Electronic Pressure Relief Valve (EPRV) Delete & Fuel Rail Pressure Sensor Update

Model Years	Models
2018 - 2019	VAH, VHD, VN

Volvo Trucks has identified through Remote Diagnostics that the vehicles in this Service Campaign have experienced faults with the Electronic Pressure Relief Valve (EPRV). To address this issue follow the repair outlined within this bulletin to remove the EPRV, inspect the Fuel Rail Pressure Sensor (FRPS) and wiring harness, followed by running an accessory kit to reprogram the vehicle.

EPRV Delete & FRPS Update

Old style Connection	New Improved Connector

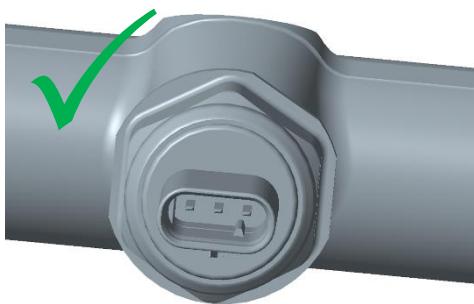
17. A product improvement has been made to the Fuel Rail Pressure Sensor (FRPS) and its wiring harness. A visual inspection of the FRPS electrical connector will indicate which sensor and wiring harness is on the vehicle.

18. Inspect the FRPS, if the Old Style Connector is found (Displayed above with red X), replace the sensor and wiring harness per Impact Instructions listed below. If the New Improved Connector is found, no farther action is needed and proceed to next step.
 - a. 2373-03-03-06 Pressure Sensor, Common Rail, Replacement, Valve Cover Removed
 - b. 2861-03-03-03 Wiring Harness, Injector, Replacement (Rear), Valve Cover Removed
19. Refer to IMPACT document ID: 2115-03-02-02 *Valve Cover, Replacement* for valve cover install procedure.
20. Using PTT Operation 1700-22-03-06 Program accessory kit: **85156014**
Note: Running this kit without removing the ePRV will result in adverse vehicle affects.
